ADDENDUM NO. 02

TO: PLANS AND SPECIFICATIONS FOR STATE OF MISSOURI

Interior and Exterior Repairs and Improvements
Missouri State Highway Patrol Hangar
Jefferson City Memorial Airport, Missouri
Project No.: R2007-01

A-202

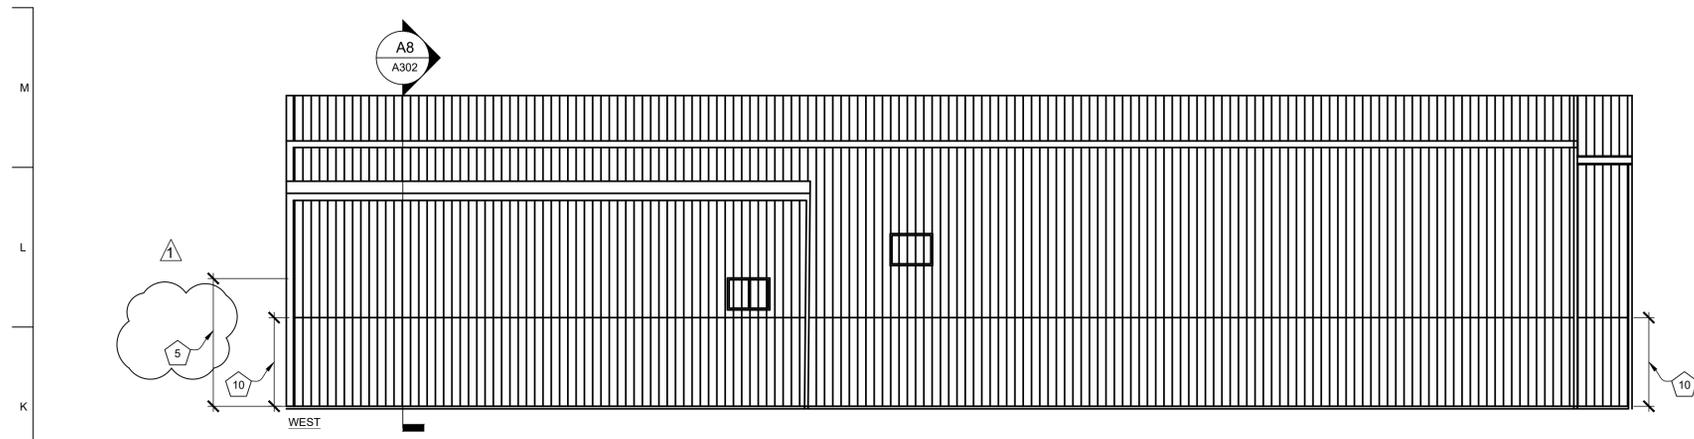
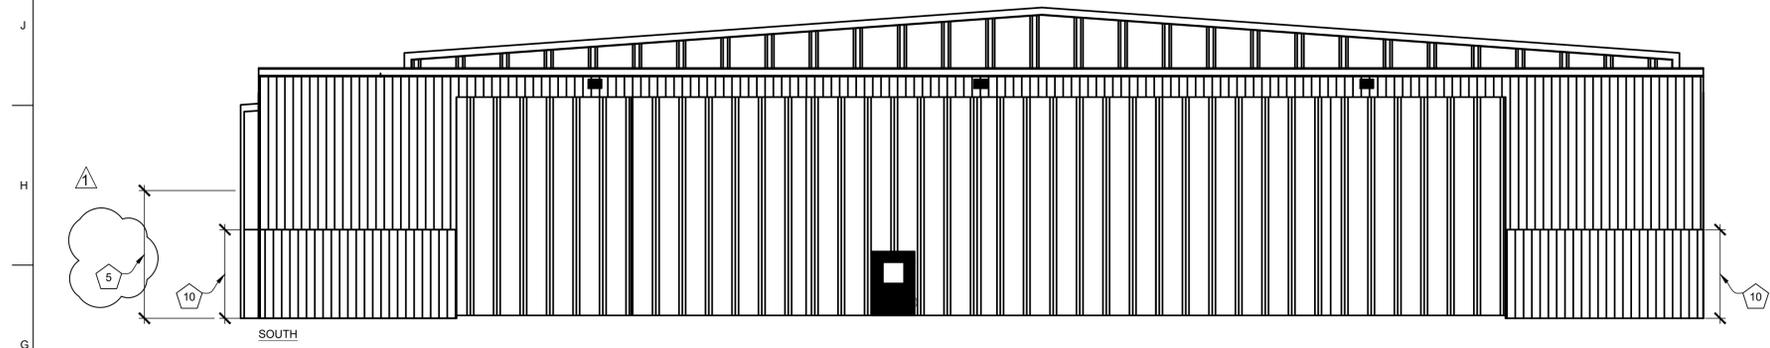
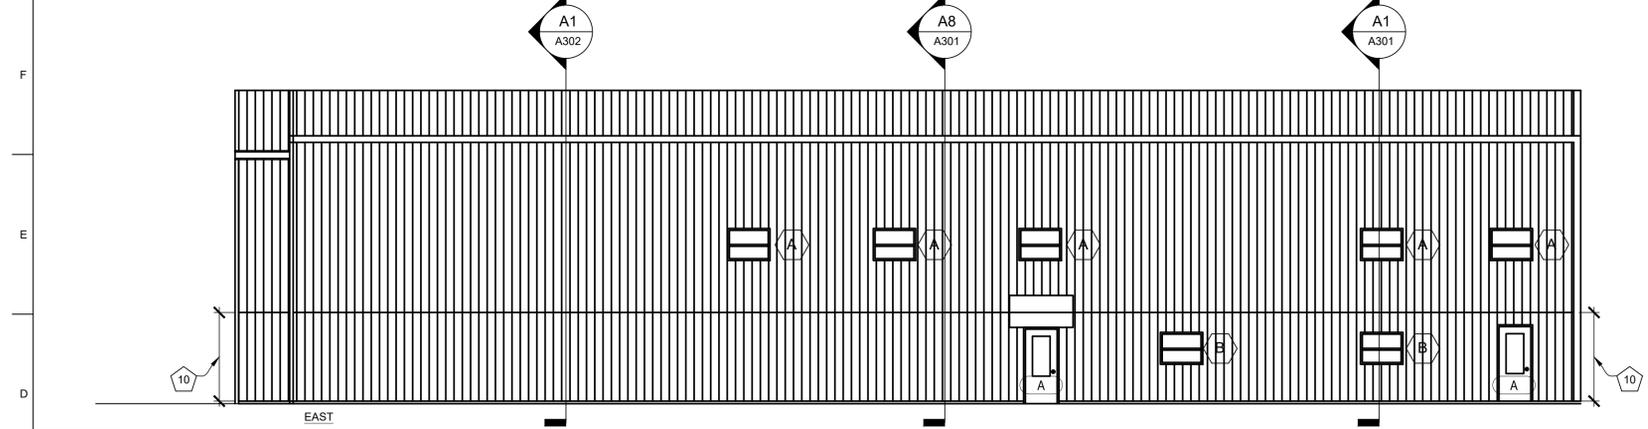
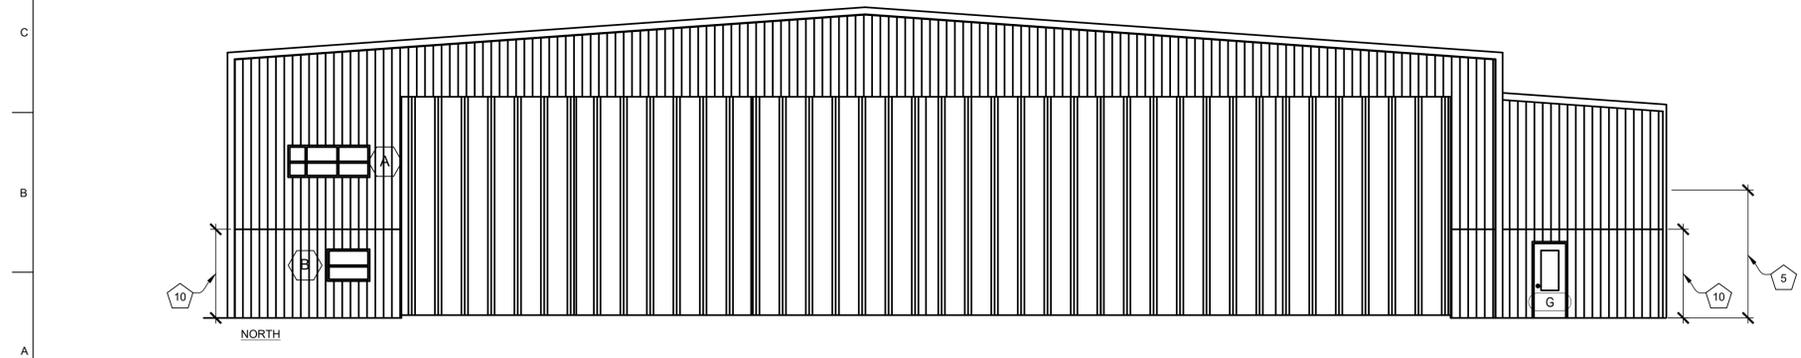
- c. ADD Note bullets 16 in detail A-Interior Elevations.
5. **Drawing A-202**
 - a. REVISE Scope of Work Notes 5 and 10.
 - b. REVISE description of Alternate #2 in alternate scope of work notes.

- c. ADD Note bullet 5 in details A1-North Elevation, D1-East Elevation, G1-South Elevation and K1-West Elevation.
6. **Drawing A-601**
 - a. ADD Detail E12-Window Detail-Alternate Bid.

E12 WINDOW DETAIL - ALTERNATE
 SCALE: 1-1/2" = 1'-0"

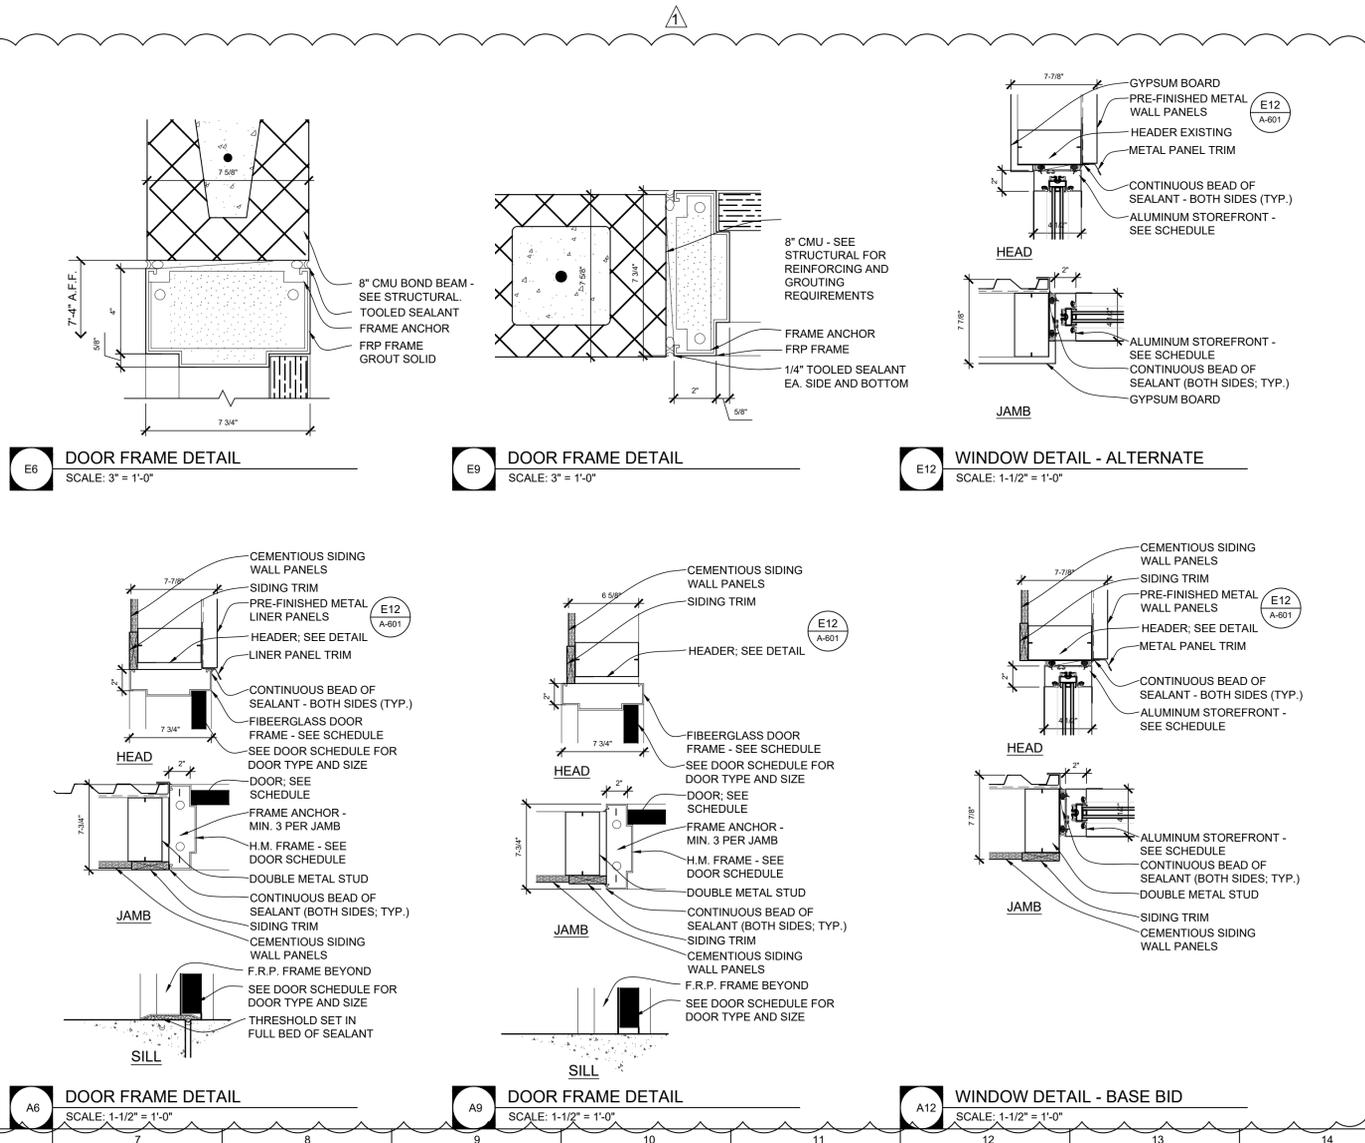
- b. REVISE dimensions for door frames on details A6, A9, E6 and E9.
 - c. Finish Schedule:
 - i. DELETE finish schedule remarks note
 - ii. DELETE remarks bullet for Lobby.
